Environmental Impact Statement (EIS) Report under the Environmental Protection Act 1994

Cannington Life Extension Project
Proposed by
BHP Billiton Minerals Pty Ltd

Prepared by: The Statewide Environmental Assessments Unit, Department of Environment and Resource Management

Figure 4-1 Proposed open pit layout (CLEP Notice of Amendment EIS, October 2011)

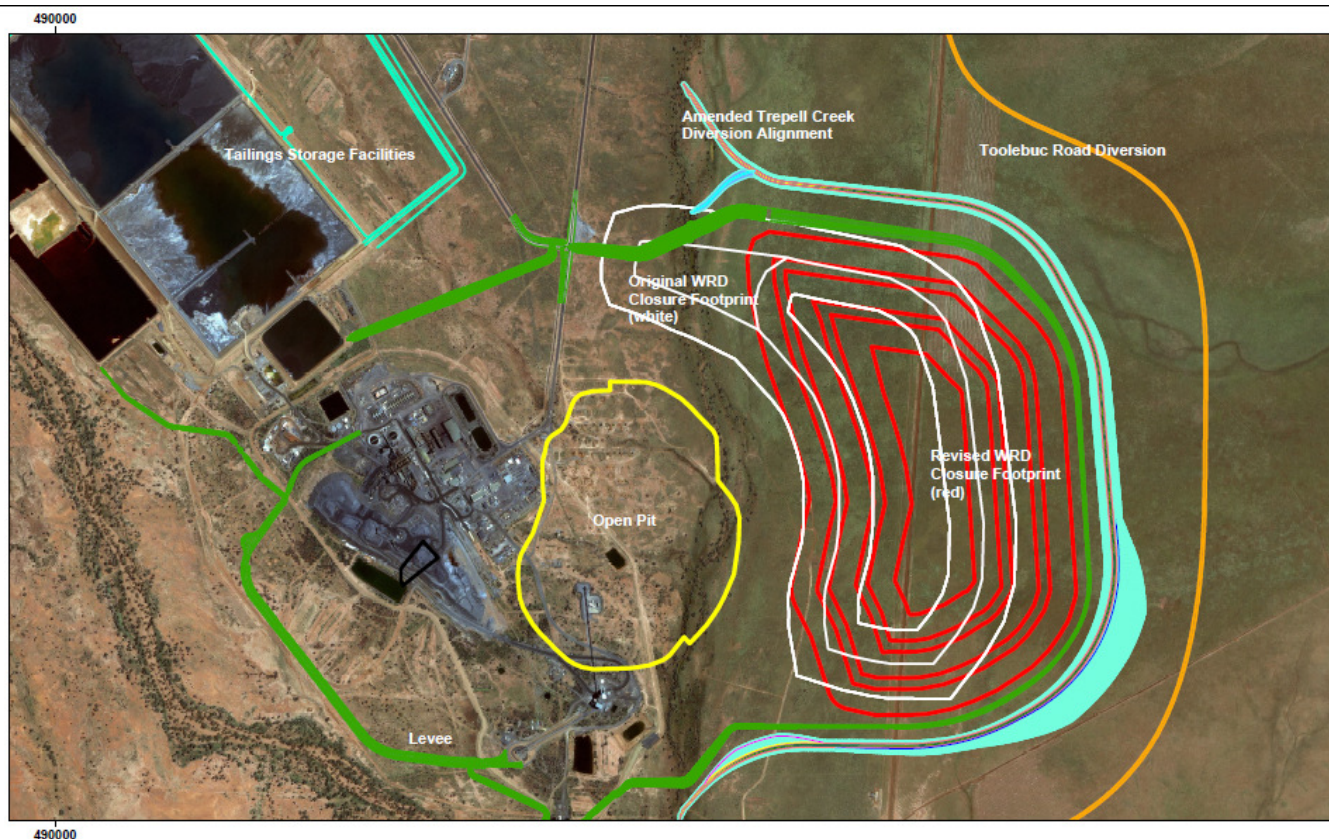
In response, BHPBC provided a detailed comparative analysis of the two preferred locations for the WRD (June, 2011) - the EIS case (east of Trepell Creek) and the location preferred by DERM (west of Trepell Creek). This document restated the reasons why the location described in the EIS was preferred by BHPBC, while identifying significant concerns with DERM's preferred location. These concerns included:

Overall, the reviewer recommended the EIS case over the alternative case. The report recommended that the location of the proposed WRD be moved to ensure that no part of the dump would be placed over the diverted bed of the Trepell Creek. Also, the angle of entry of the diversion to the existing creek channel would be changed to reduce potential for ponding. The new concept design and configuration for the WRD and upstream tie-in for Trepell Creek are shown in Figure 4.1 Proposed open pit layout (CLEP Notice of Amendment EIS, October 2011).

BHPBC subsequently submitted an amendment to the EIS based on the findings of the reviewer's report. The revised waste rock dump will now be located away from the original creek channel and the infilling of the creek channel would be limited to retention dams and haulage roads. The revised WRD would have a smaller footprint (150 ha compared to 160 ha) and be increased in height to 90m (previously 60m), which would be achieved in a series of three 30m lifts.

BHPBC committed to implementing these recommendations in the detailed design, construction and management of the WRD. This review finds that the changes to the location of the WRD and the commitment to undertake further comprehensive design work for the WRD and related structures, adequately addresses matters concerning the location of the WRD.

Revised design and related details would need to be described in detail in an amended EM plan.
